SAFETY EVALUATION BY THE OFFICE OF NUCLEAR REACTOR REGULATION

SUPPORTING AMENDMENTS NO. 19 TO LICENSES NOS. DPR-32 AND DPR-37

SURRY POWER STATION UNITS 1 AND 2

DOCKETS NOS. 50-280 and 50-281

Figure 1

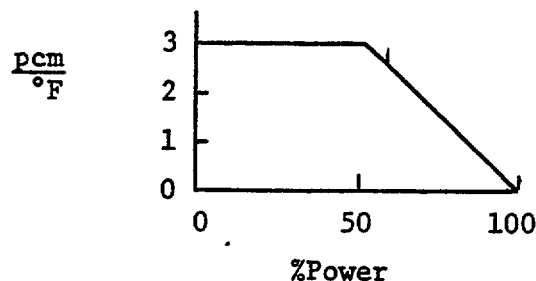
The Virginia Electric and Power Company has reexamined the accidents and transients presented in the Final Safety Analysis Report (FSAR) for sensitivity to a positive moderator coefficient. With the exception of the rod withdrawal from subcritical and rod ejection accidents all transients reanalyzed used a constant moderator coefficient of $+3 \text{ pcm}/^\circ\text{F}$ ($+0.3 \times 10^{-4} \Delta\text{K}/^\circ\text{F}$). This is conservative since, as shown in Figure 1, the coefficient is constant to 50% power and then decreases linearly to zero at 100% power.

The rod ejection accident was analyzed with a moderator coefficient which approaches zero (becomes less positive) with increasing power. The rod withdrawal from subcritical was analyzed in the FSAR with a moderator coefficient of +10 pcm/°F and therefore bounds the requested Technical Specification change.

1. Except during low power physics tests, the reactor shall not be made critical at any temperature above which the moderator temperature coefficient is more positive than:
 - a) +3 pcm/°F at less than 50% of rated power, or
 - b) +3 pcm/°F at 50% of rated power and linearly decreasing to 0 pcm/°F at rated power.
2. In no case shall the reactor be made critical with the reactor coolant temperature below DTT +10°F, where the value of DTT + 10°F is as determined in Part B of this specification.
3. When the reactor coolant temperature is below the minimum temperature as specified in E-1 above, the reactor shall be subcritical by an amount equal to or greater than the potential reactivity insertion due to primary coolant depressurization.
